75 North Main Street

Parking and Site Plan Review

Response to Comments

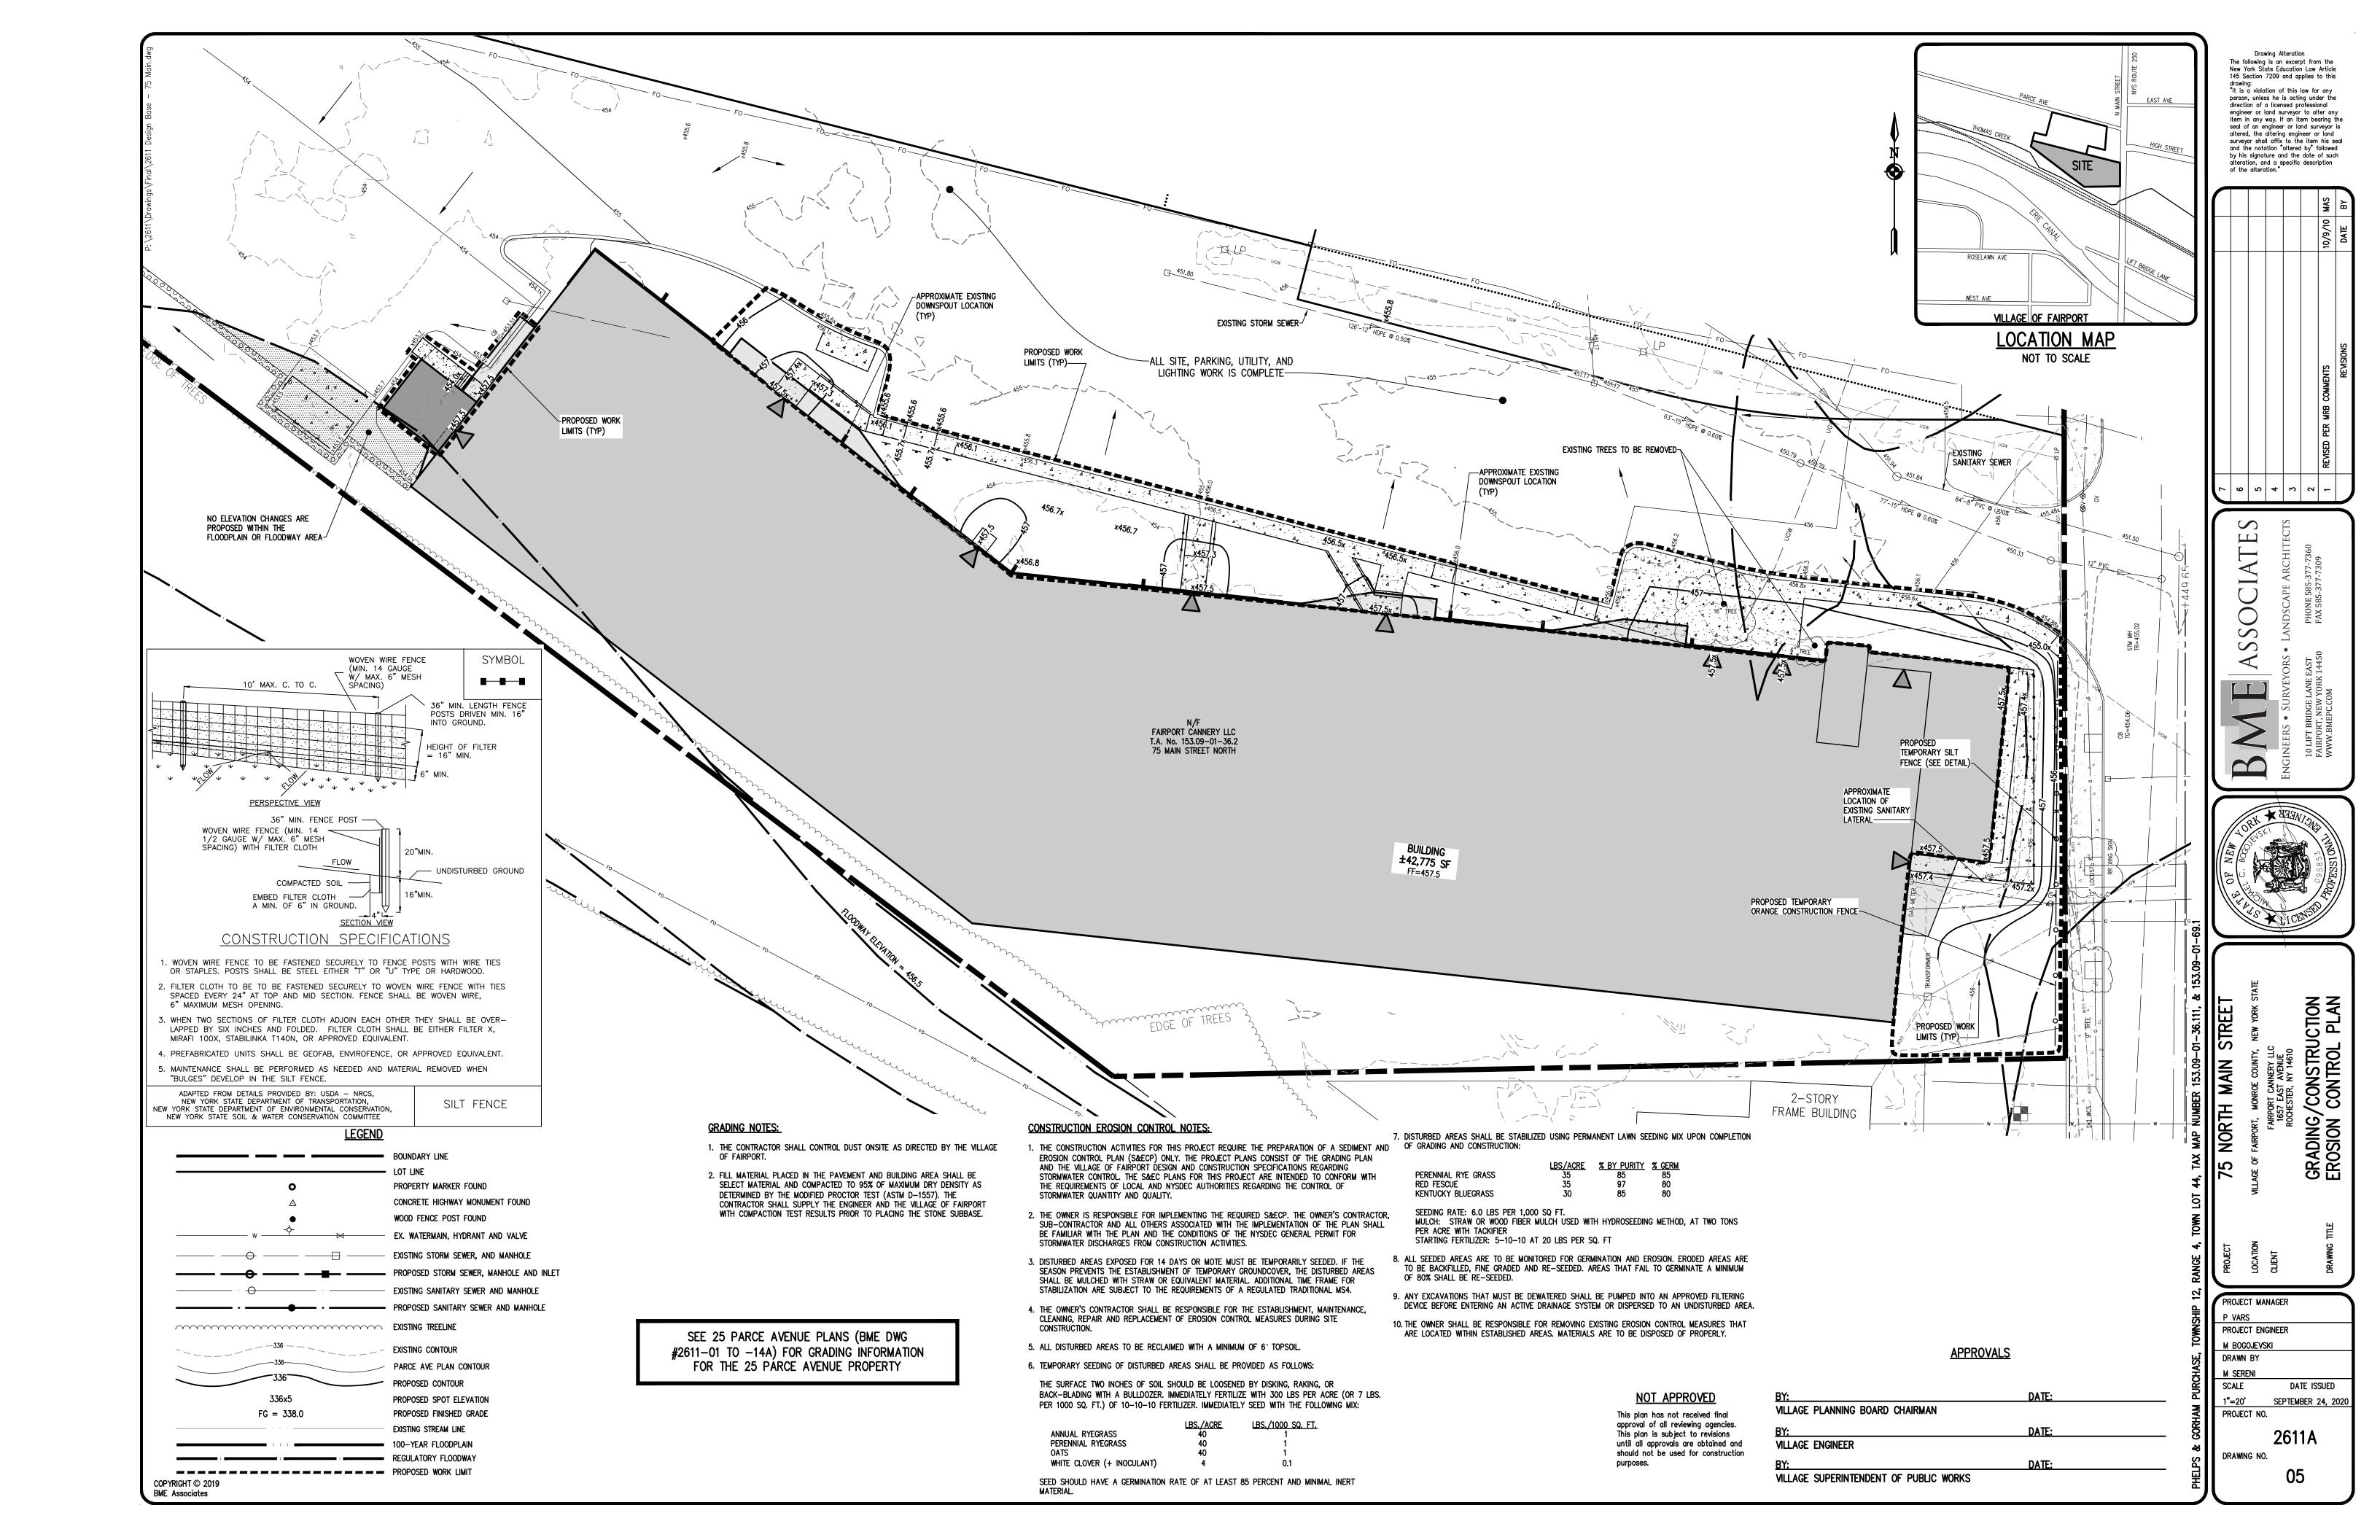
c. Drawing No. 04 shows (6) proposed handicap accessible spaces for 75 N Main whereas the 75 N. Main/25 Parce Ave Parking Tabulation Worksheet submitted 9/24/2020 only states that there will be 4. Please update accordingly.

4. The site plan should clarify what features are existing and what improvements are being proposed. Maybe an existing conditions plans should be added for clarity. All existing utilities including drainage and stormwater management facilities, stockpiles, lighting, and parking lot striping should be shown.

The Parking Tabulation Worksheet has been updated to reflect the six accessible spaces shown on the 75 N. Main Street Parking and Site Plan (dwg. 2611A-04).

We have revised the Parking and Site Plan (dwg. 2611A-04) to reflect the items already installed with the overall parking area as existing on the plan. We have also revised the Grading and Construction Erosion Control Plan (dwg. 2611A-05) to reflect the grading previously completed for the parking area as existing on the plan, along with any other items already installed. The intent is to clearly show that the items with the parking area that has been completed as existing, and the new proposed items to be installed are along the building, outside of the previously completed parking area.

CANNERY PARKING

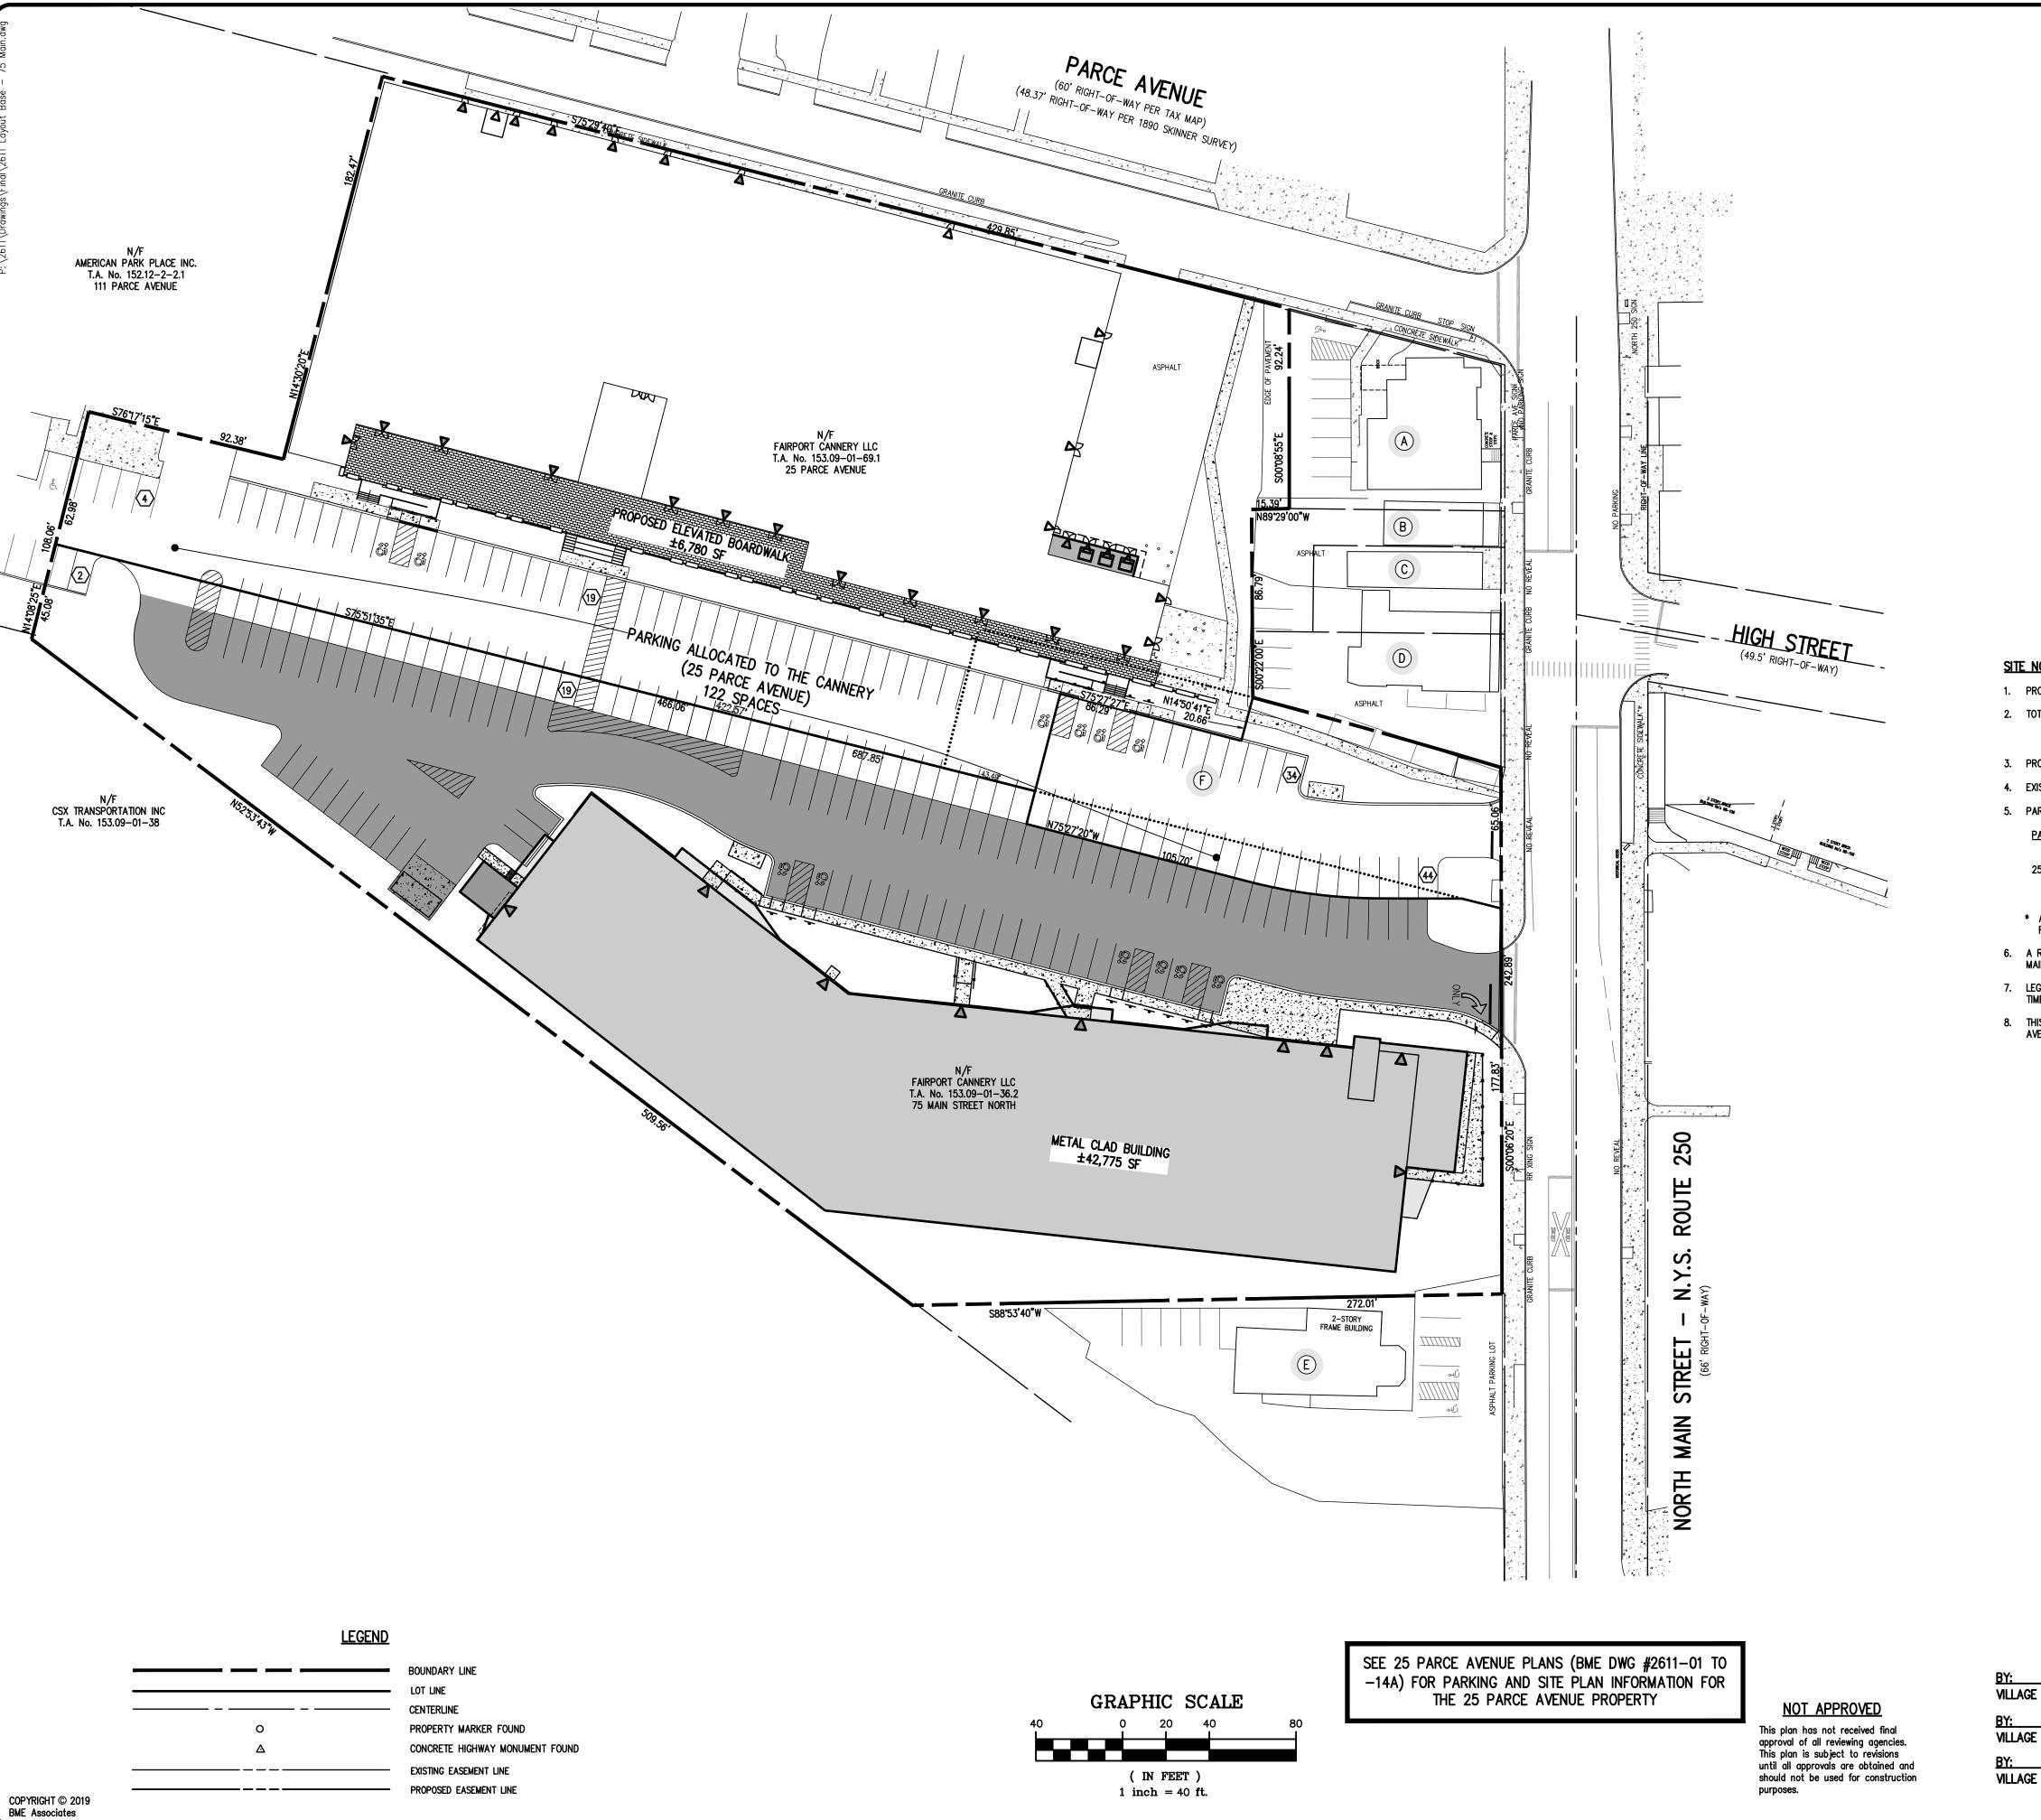
1. It is my understanding that an Amended Site Plan approval for the 25 Parce Ave project is required to be completed as part of this application. There are notes and parking data on the approved plan set that are incorrect and need to be corrected. Please note that we did not receive the Amended 25 Parce Ave plans.

b. It was our understanding that the land banked parking spaces (4) in total, that were previously approved were going to become or have already been fully paved spots. Should the tabulation be updated to reflect that these are actual spaces now and not landbanked?

The Cannery Parking Plan (dwg 2611-22) is enclosed to reflect the parking allocated to the Cannery building (25 Parce Avenue). The Site Notes have been updated to reflect the parking numbers, and the parking calculation table is also provided.

The Cannery Parking Plan (dwg 2611-22) and the 75 N. Main Street Parking and Site Plan (dwg 2611A-04) have been updated to reflect the land banked parking as installed. The tabulation table was also updated.
